UNITED COSTUME LIMITED (BUILDING-02)

20 February 2025

2. Observation:

Observation-02: Inconsistencies in design report and material strength (Production Building-02).

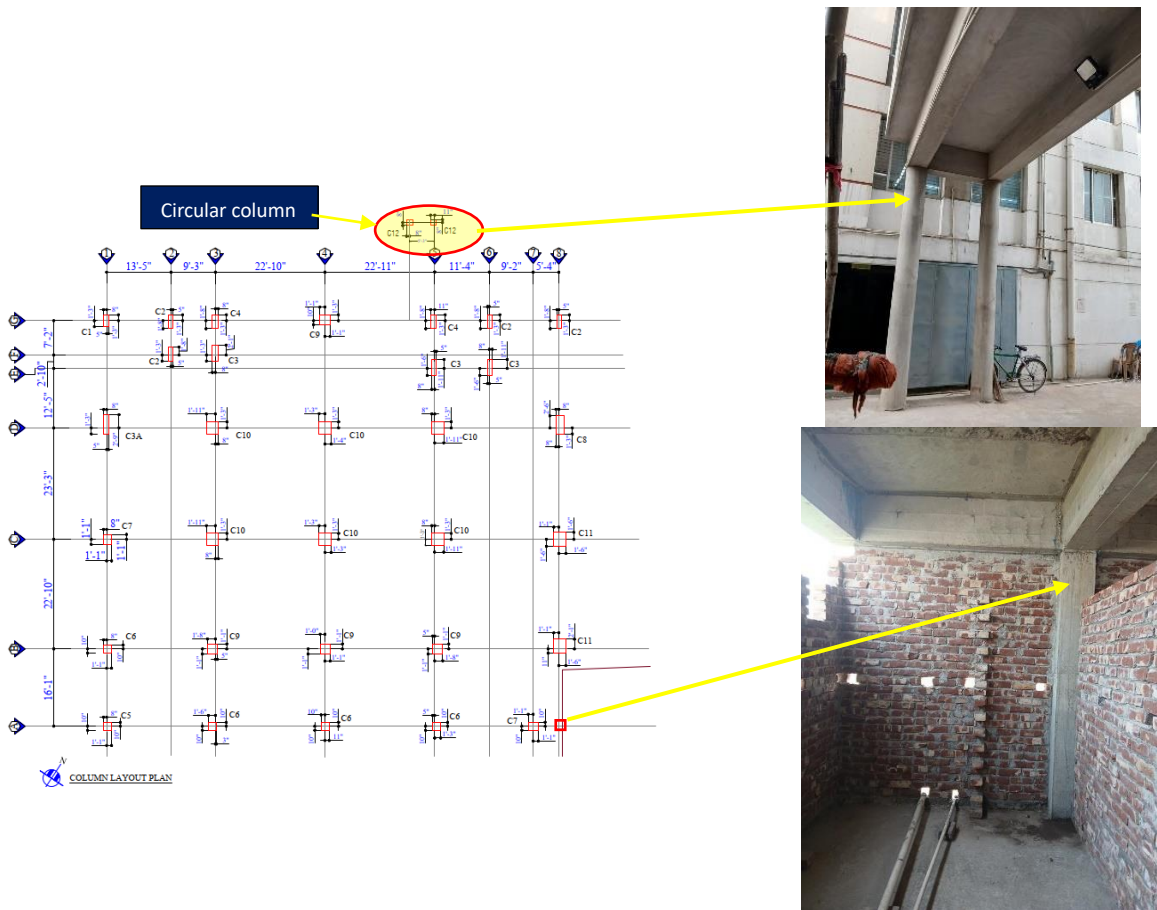
Description: During the inspection, the design report was found on-site, and the following observations were noted:

- The Response Modification Coefficient ($R = 8$) has been considered in the design, but the required justification or supporting calculations were not provided in the report.
- The rebar design strength was considered as 72.5 grade, whereas the test report indicates 60 grade rebar.
- The material strength was considered as 24 MPa for beams and slabs and 28 MPa for columns, but no cylinder test report was available on-site.
- Ongoing construction quality and workmanship were observed and monitored less by the building engineer. Segregation in concrete was observed in the beams, columns, and slabs.

The building engineer is required to verify the in-situ concrete strength by extracting 100mm diameter cores from four columns (preferably from the lower tier of the building), as well as from the beam and slab, or by referring to existing cylinder test reports from the specific concrete mix ratio. Also, Check the construction quality by Non-Destructive Test (NDT) & Destructive Test (DT).

Observation-03: Mismatch/Lack of information in as-built drawing (Production Building-02).

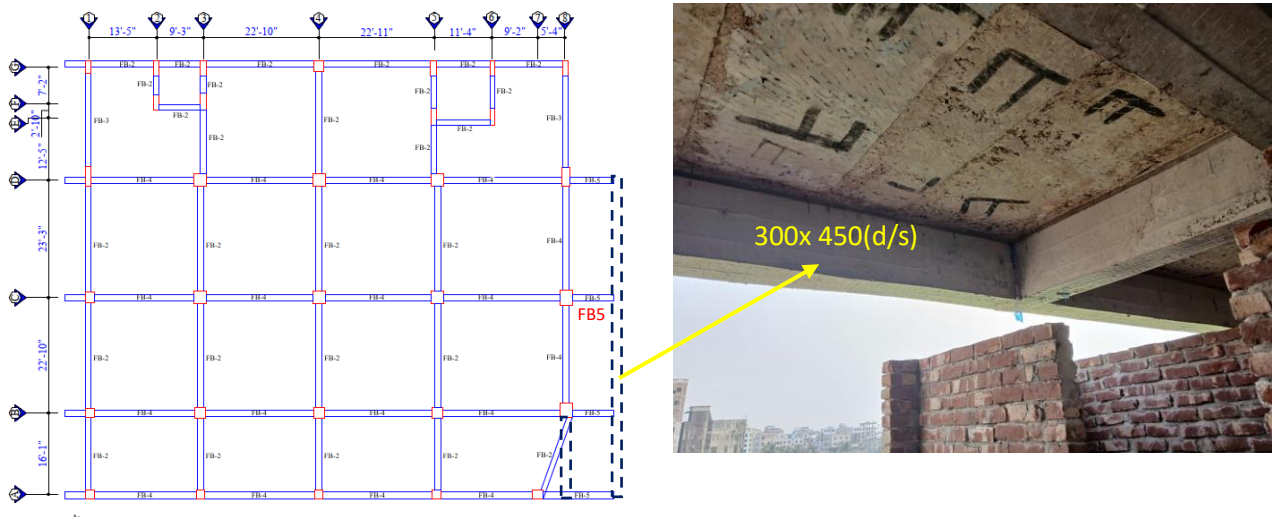
Description: A 300 x 300 mm column was found at grid A-08, which was not shown in the column layout. Additionally, two 400 mm diameter circular columns were found in the connection bridge instead of a square column.

The building engineer is required to survey the structures and prepare comprehensive as-built drawings, including necessary foundation details.

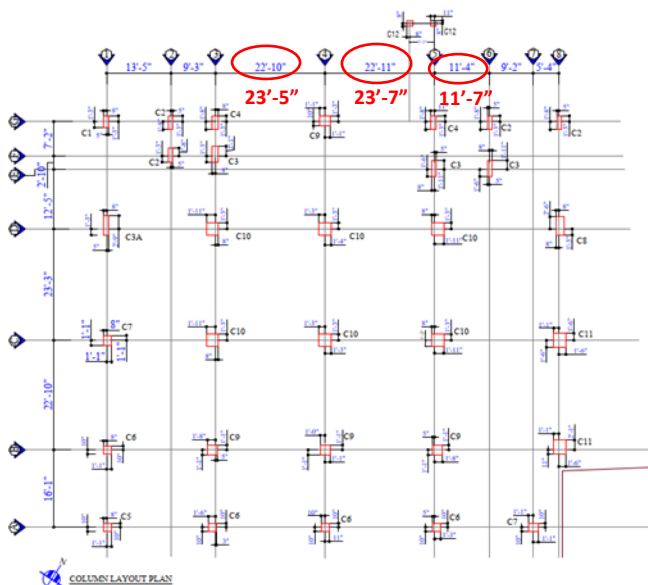
Description: A beam was found from 8-B to 8A instead of 8B to 7A, and a sub-beam was observed in the cantilever portion [size 300x450 (d/s)], which was not shown in the beam layout. Additionally, FB5 was found to be 300x450 (d/s) instead of 300x600 (d/s).

COLUMN LAYOUT PLAN

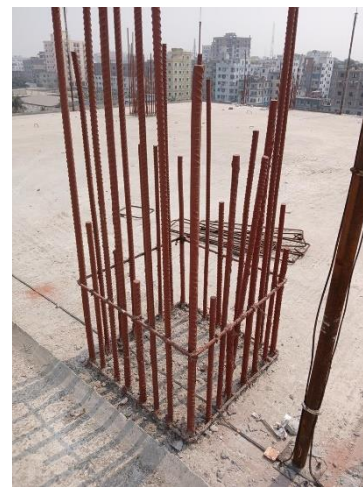
Description: The grid dimensions between 3-4, 4-5, and 5-6 were found to be 23'-5", 23'-7", and 11'-7", respectively, which differ from the drawings.

Description: On the 4th floor, discrepancies in rebar were observed:

- At C10, 28 bars (10-25mm + 18-20mm) were found instead of the 30 bars.
- At C11, 30 bars (8-25mm + 22-20mm) were found instead of 34 bars.
- At C4, 16 bars (5-25mm + 11-20mm) were found instead of 18 bars.
- At C3, 20 bars of 20mm were found instead of the specified 6-25mm + 14-20mm."

Observation-05: Connection bridge is rigidly attached to the adjacent building (Production Building-02).

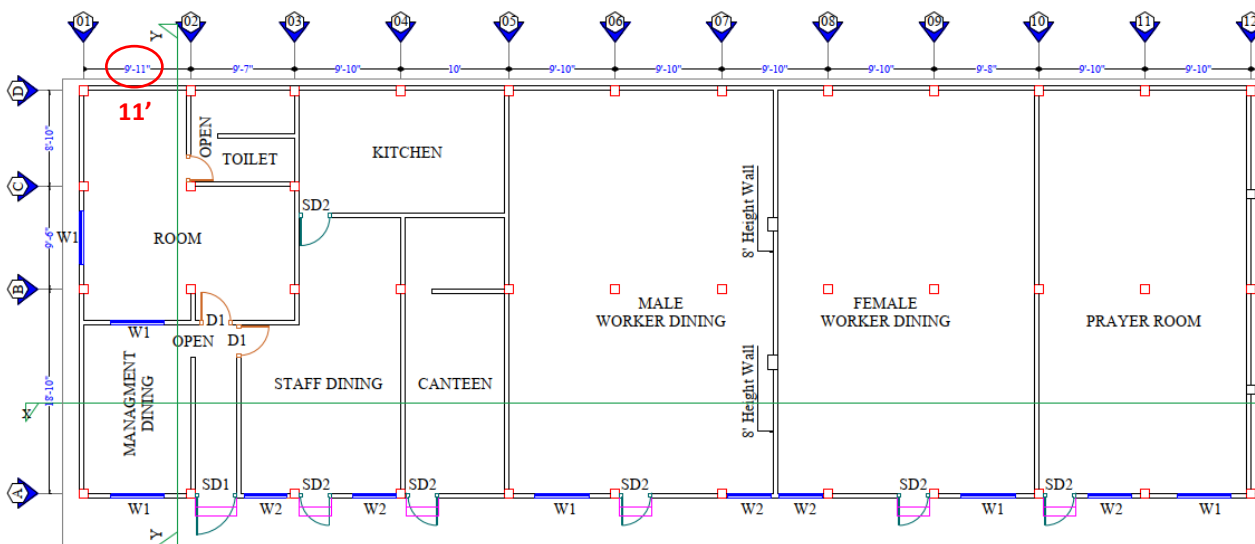
Description: The structure shows no visible signs of expansion joints or flexible connections to the adjacent building.

A clear gap is required to be provided with an expansion joint, and the gap is to be filled with appropriate compressible materials as per the engineer's recommendation. Otherwise, consider the design of the main building.
